HISTORIC PRESERVATION BOARD STAFF REPORT

City Center (Doc's) - 10 N. Swinton Avenue

Meeting	File No.	Application Type
August 3, 2022	2022-060	CBD Waiver Request

W. Atlantic Avenue Streetscape Section

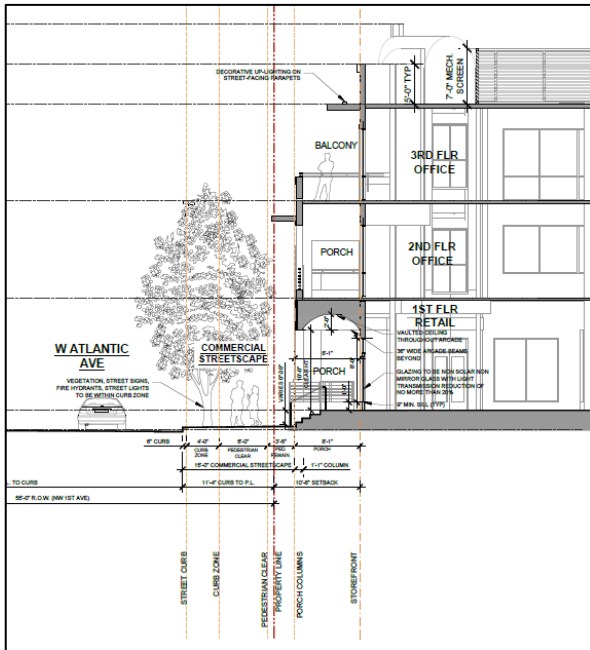
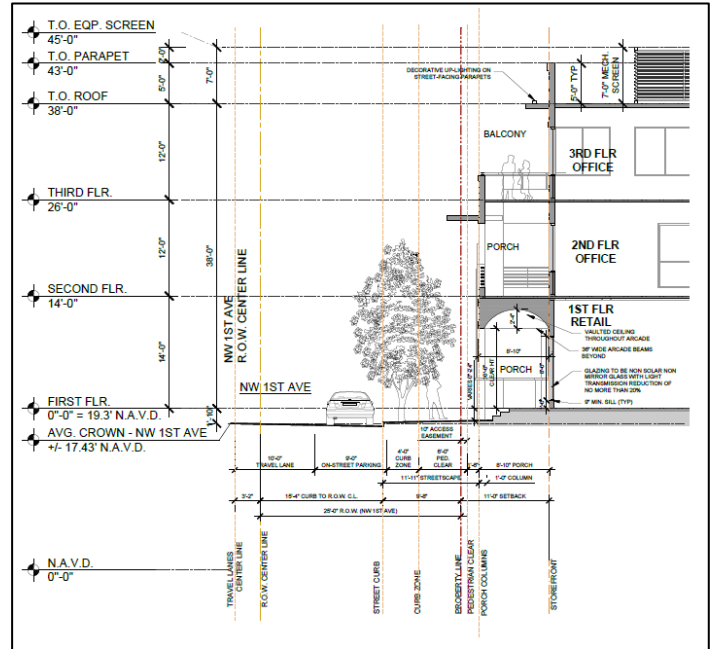
Diagrams provided demonstrate the porch does not encroach more than 8 feet into the minimum setback, as the building is setback more than the minimum of 0 feet, and that the minimum curb zone and pedestrian clear zone are met or exceeded, which are critical requirements that must be met in all instances of the proposed waiver. It is noted that architectural features in the diagrams below that extend into the public ROW must be removed and are not part of this consideration.

- A. Move to continue with direction
- B. Recommend approval to the City Commission of the Waiver request to use a Porch frontage type instead of a Storefront or Arcade frontage type, *provided the Porch encroaches no more than 8-feet into the minimum setback areas and the minimum curb zone and pedestrian clear zones are provided* for the property known as **City Center, Old School Square Historic District** by finding that the request and approval thereof is consistent with the Comprehensive Plan and meets the criteria set forth in the Land Development Regulations.
